Certified Action Of the City of Raleigh Planning Commission

Case File / Name: S-8-10 / Cobblestone Subdivision

S-8-10 Cobblestone Subdivision – Preliminary Subdivision Plan

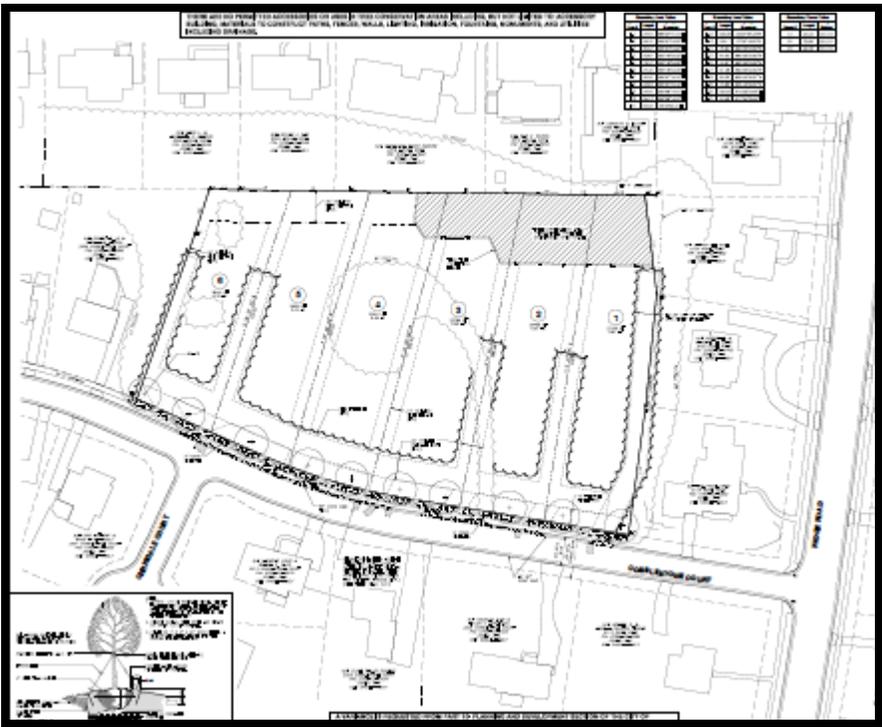
The median lot frontage of the surrounding lots is 105', 80% of which is 84'. The proposed lot frontages in the proposed subdivision range from 76' to 81'. The median lot size of the surrounding peripheral lots is .375 acres, 80% of which is .3 acres. The proposed lot sizes in the proposed subdivision range from .38 acres up to .52 acres.

This development constitutes an "infill project" of less than 5 acres surrounded on at least 66% of its periphery by developed single-family detached dwellings, and all proposed lot frontages are less than 80% of the median of the surrounding lots. The proposed lot sizes, however, do exceed 80% of the median lot sizes of the surrounding lots.

TREE CONSERVATION: The preliminary plan shows .283 acres or 9.4% of secondary Tree Conservation Areas on the site, which is less than the City Code requirement. If a final tree

survey of the property reveals that additional areas are available to meet the 10% Code requirement, additional tree conservation areas will be provided and the preliminary plan will be revised accordingly. Tree conservation areas which are shown on the preliminary plan are contiguous and run across rear portions of lots 1-4.

Staff finds that the proposed subdivision meets infill standards 1-3 found below.

1. The lot lines are angled from the street in a similar manner as typical surrounding lots.
2. Lots consist of more than 4 lines as is typical of several of the surrounding lots. The existing lots prior to the recombination consisted of more than 4 lot lines.
3. The building envelopes for the proposed new lot(s) are placed in such a way that they are not one behind the other when viewed from the public street. Lots proposed may be adequately served by City services.

PEDESTRIAN: Proposed sidewalk locations conform to City regulations. A sidewalk is required and is proposed on the preliminary subdivision plan along the entirety of the property’s Cobblestone Court frontage.

Stormwater quantity regulations will be met through the use of 6 underground storage pipes; one on each lot.

- (1) That the Planning Commission finds that this infill subdivision meets the lot layout standards of Section 10-3032(d);
- (2) That restrictive covenants be recorded with the subdivision which require each lot to be developed so that at least two automobile parking spaces are provided on each lot and that they be configured in such a way that at least two automobiles can be parked without the need for one automobile to be parked behind another;

- (3) That prior to the issuance of a grading permit or the recording of the plat whichever first occurs, the final tree conservation plan must be approved by the Forestry Specialist in the Inspections Department. The plan must show metes and bounds descriptions of all tree conservation areas, and tree protection fence around all tree conservation areas. Tree protection fence must be located in the field and inspected by the Inspections Department. A copy of the approved plan is placed on file in the Planning Department;
- (4) That a stormwater control plan with a stormwater operations and maintenance manual and budget shall be approved by the Stormwater Engineer in compliance with Part 10 Chapter 9, including the designation of buffer areas and open space areas for stormwater purposes prior to grading or the approval of construction drawings, whichever event comes first;
